Access Compliance Report

Public Rights-of-Way

(Curb Ramps)

Intersection ID: 49556	Main Street: TEXTILE_WY	Cross Street: NODA_BV	Location: NW
ADA ID: 89B9242E24E8	Ramp Type: Perp	Initial Pass/Fail: Fail	Overall Compliance: No
Severity Score: 12.5			
Codes/Mitigation Info/Possible Solution		Field Measurements/Component Compliance

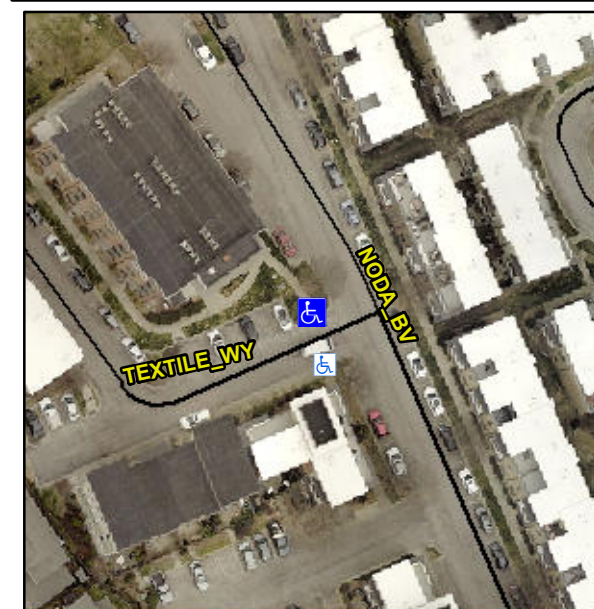
Not Found, R304.2.2

Compliance	Description	Data	Compliance	Description	Data
N/A	Ramp Length (in)	61.5	No	Ramp Slope (%)	8.5
Yes	Ramp Width (in)	48.0	Yes	Ramp XSlope (%)	1.9
N/A	Flare Type LT	N/A	N/A	Flare Type RT	N/A
N/A	Flare Slope LT (%)	N/A	N/A	Flare Slope RT (%)	N/A
N/A	Flare Traversable LT?	N/A	N/A	Flare Traversable RT?	N/A
N/A	Landing Length (in)	N/A	N/A	DWS Provided?	N/A
N/A	Landing Width (in)	N/A	N/A	DWS Contrast?	N/A
N/A	Landing Slope (%)	N/A	N/A	DWS Length (in)	N/A
N/A	Landing X Slope (%)	N/A	N/A	DWS Full Width?	N/A
N/A	Landing Curb? (Y/N)	N/A	N/A	DWS Offset (in)	N/A
N/A	Shared Landing?	N/A			
N/A	Gutter Ponding?	N/A	N/A	Gutter Slope (%)	N/A
N/A	Gutter Lip Ht (in)	N/A	N/A	Gutter X Slope (%)	N/A
N/A	Painted X Walk1?	No	N/A	Painted X Walk2?	N/A
	X Walk 1 Direction	To S		X Walk 2 Direction	N/A
N/A	X Walk 1 Width (in)	N/A	N/A	X Walk 2 Width (in)	N/A
	X Walk 1 Slope (%)	1.0		X Walk 2 Slope (%)	N/A
	X Walk 1 X Slope (%)	1.5		X Walk 2 X Slope (%)	N/A

Remove & Replace Entire Ramp.
